In the matter of the Fingerboards Mineral Sand Project EES

Inquiry and Advisory Committee

Expert Witness Statement of John Sweeney

Figure 1: Hydrogeological conceptual model

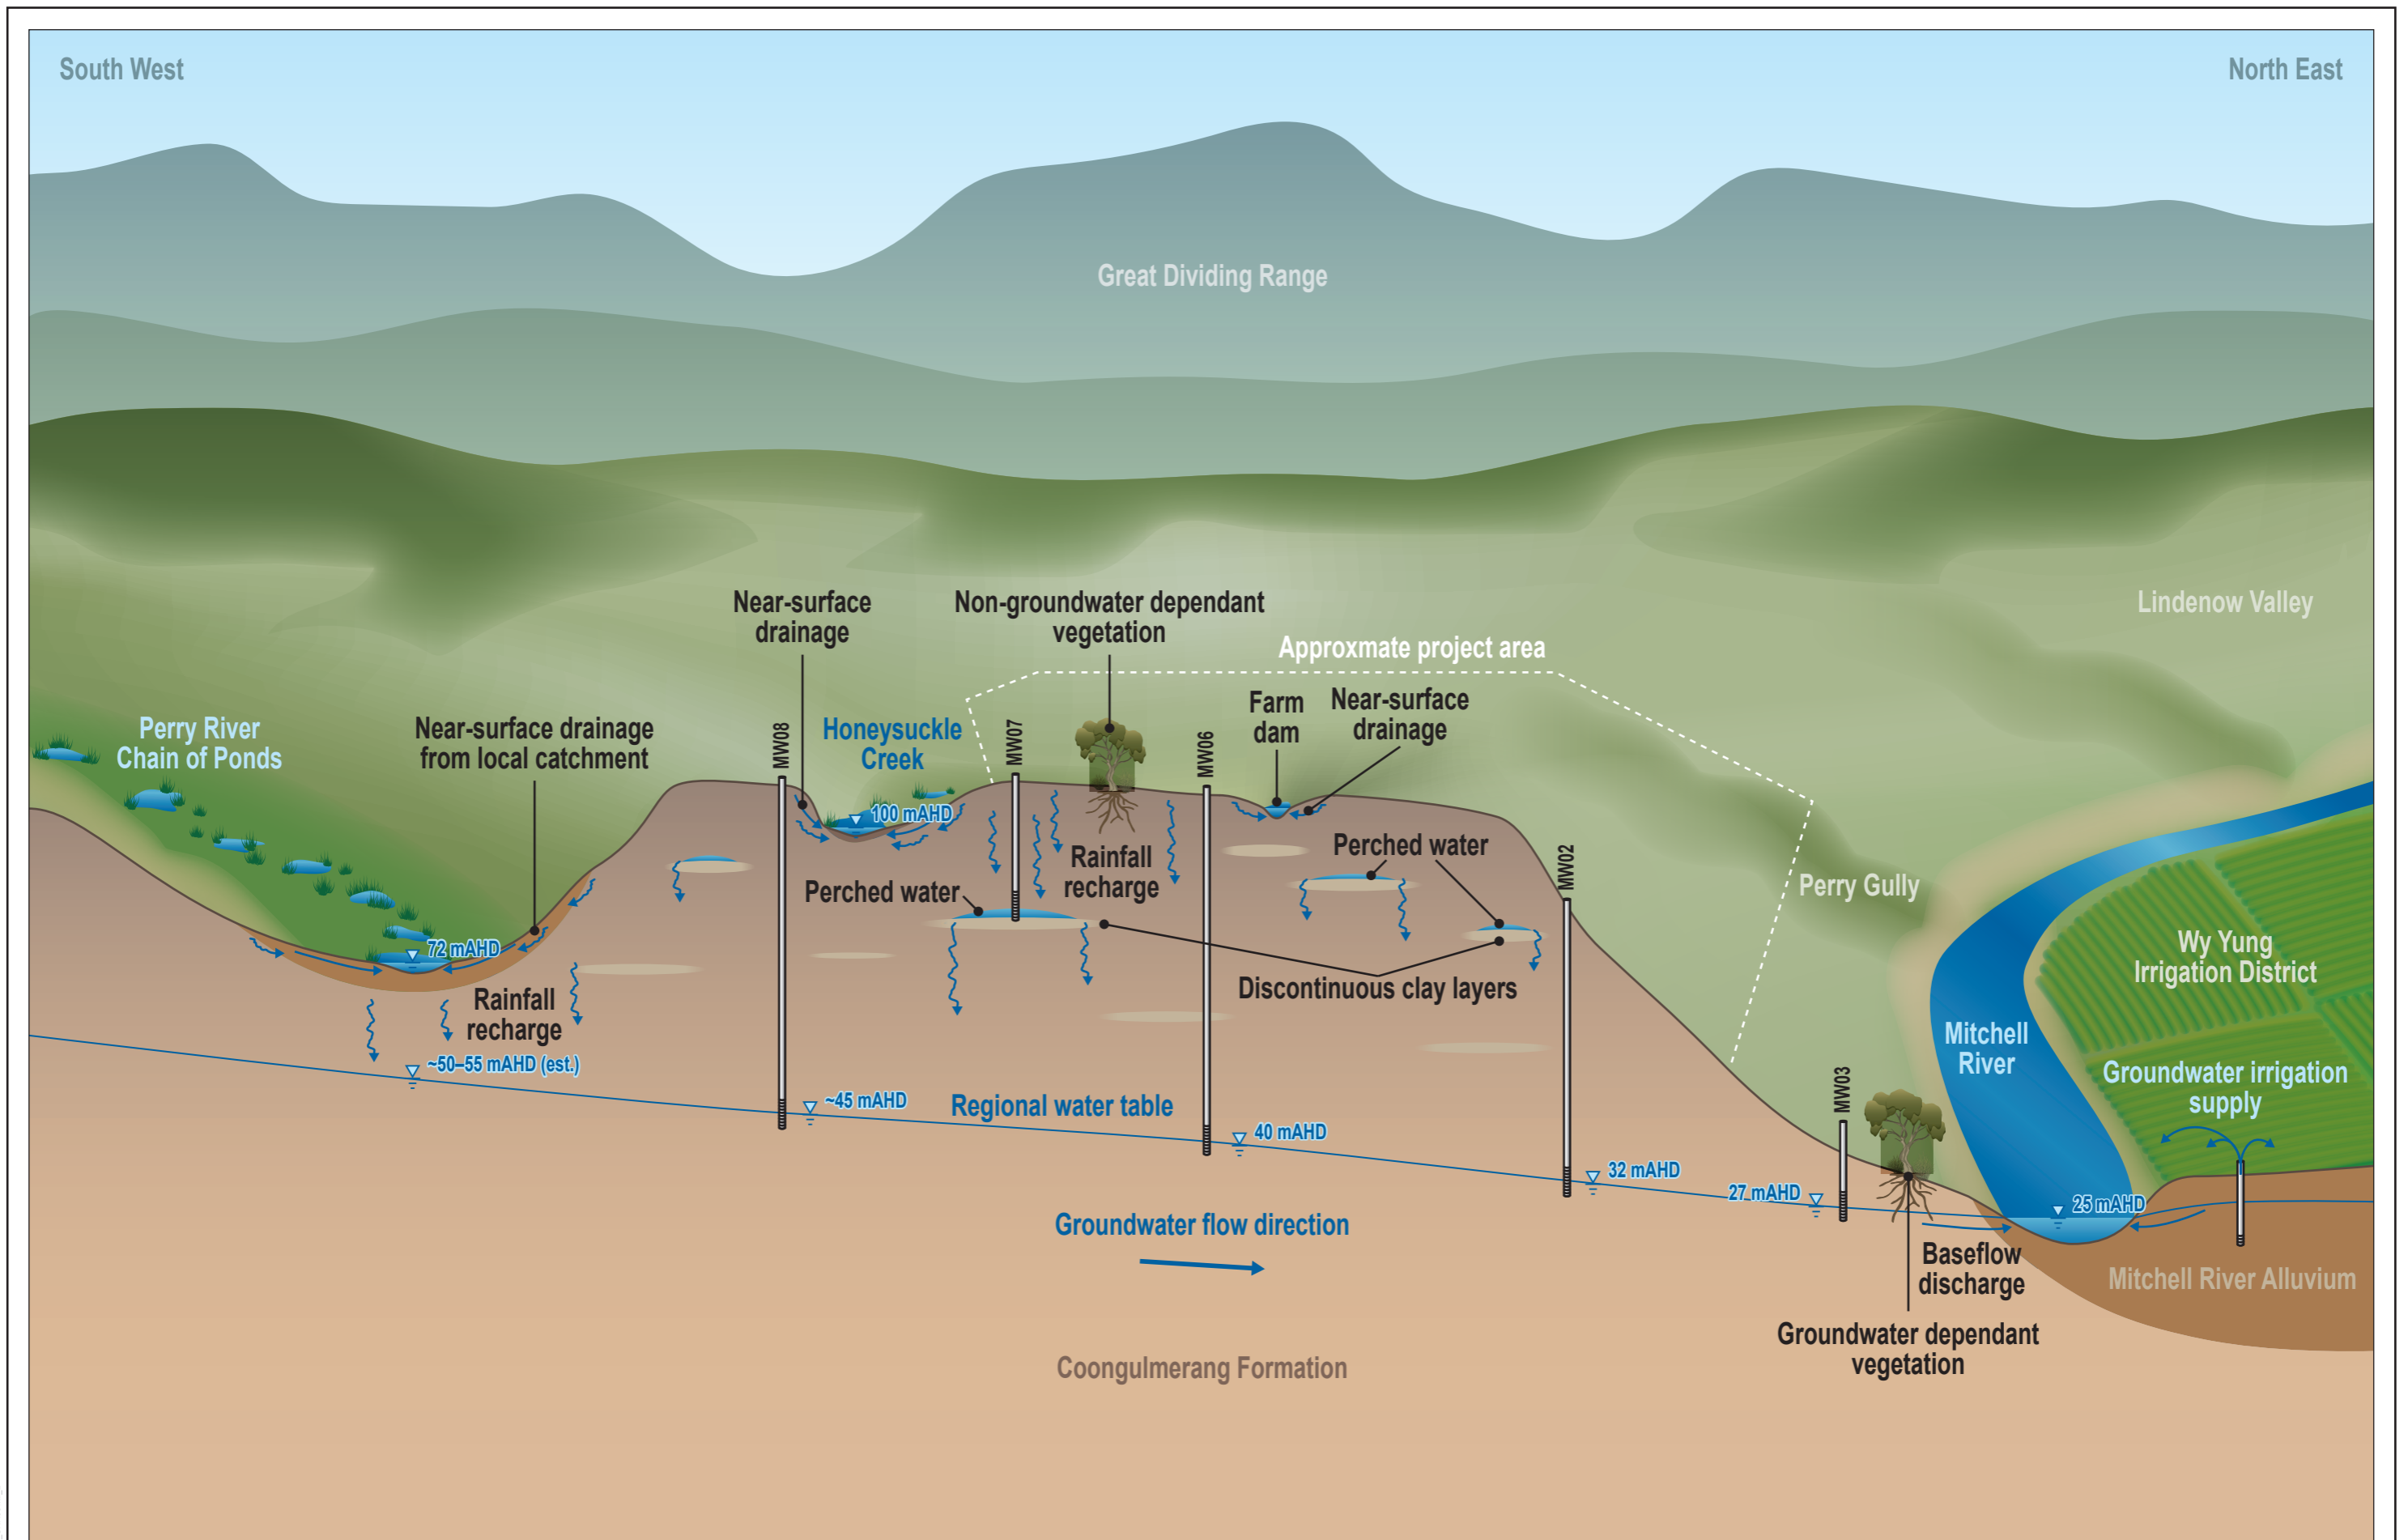
Submission 716 (p.29) states that “an alternative interpretation of the data presented, is groundwater beneath the east half of site flows toward Mitchell River, and beneath the west half of site toward Perry River. This possibility does not appear to have been considered in the model conceptualisation and risk assessment.”

The inferred groundwater flow direction adopted by the GSWIA is shown on Figures 4-10 to Figure 4-15 of the GSWIA report. The inferred flow direction adopted by the GSWIA is based on the available measured groundwater levels and indicates that groundwater flows in a north and north-easterly direction across the mine area towards the Mitchell River. This is consistent with the Mitchell River acting as a regional groundwater discharge point.

The alternative interpretation presented in Submission 716 was considered during development of the conceptual hydrogeological model, however in my opinion it was not supported by the available data. For a groundwater divide to exist west of the current groundwater monitoring network it would require Perry River to be a groundwater discharge feature. I do not believe this to be the case based on the following lines of evidence:

1. The Perry River is at a much higher elevation (~75 m AHD) compared to the Mitchell River (~23 m AHD) (refer to Figure 1).
2. The presence of a permanent chain of pond landscape along the Perry River valley suggests it is not a significant groundwater discharge feature. A regional groundwater discharge feature would have similar flow characteristics to the Mitchell River.
3. Groundwater level contours projected towards the west remain below the base of the Perry River.
4. Exploration drilling west of the mine area support the projected groundwater levels in the vicinity of the Perry River.

Figure 2: Possible locations of spring fed dams

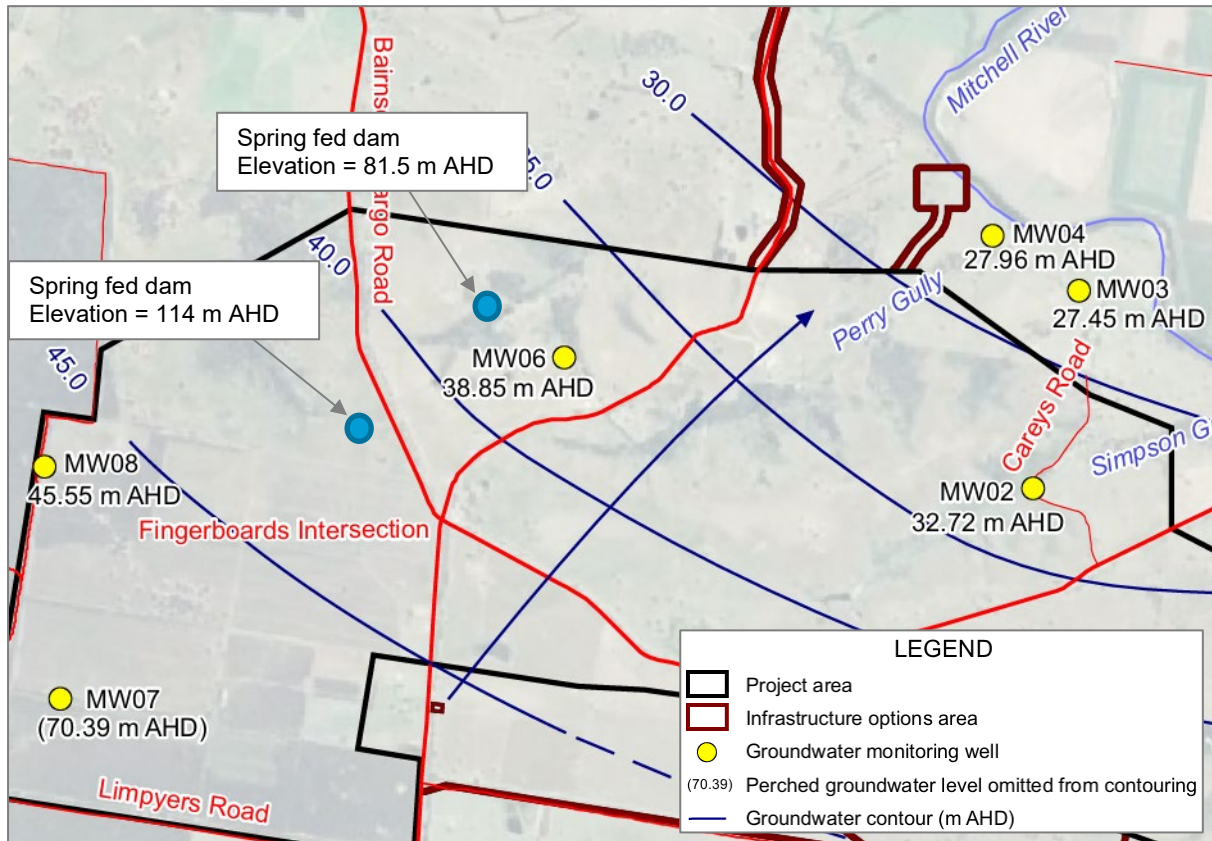
A request was made to SRW during the baseline assessment to provide the available information on spring fed dams, however this was not made available. During the TRG review process, SRW commented that “Section 2.6.1 of the Draft Work Plan states ‘Scattered farm dams and soaks occur across the mining licence.’ The report needs to confirm what actions have been taken to search for springs and soaks and evidence this, and what risk is posed by the mine.”

It is my interpretation that most farm dams within and immediately surrounding the project area would be positioned several 10’s of metres above the inferred watertable in the Coongulmerang Formation aquifer (refer to Figure 1). In preparation of this statement I sought further information from Kalbar on the possible location of farm dams that might be considered ‘spring fed’ by local landowners so that a more direct assessment could be offered. Kalbar identified two dams shown on Figure 2 that might be considered by landowners to be spring fed, based on anecdotal evidence.

When compared to the inferred groundwater levels in the area (also shown on Figure 2), the base of these farm dams are expected to exist at elevations between 43 m and 75 m above the watertable.

Therefore, I believe that if these dams are supported by seepage, that seepage it would be attributed to the same near-surface drainage processes described for the natural chain of ponds further west of the project area (refer to Sections 6.2 and 6.3).
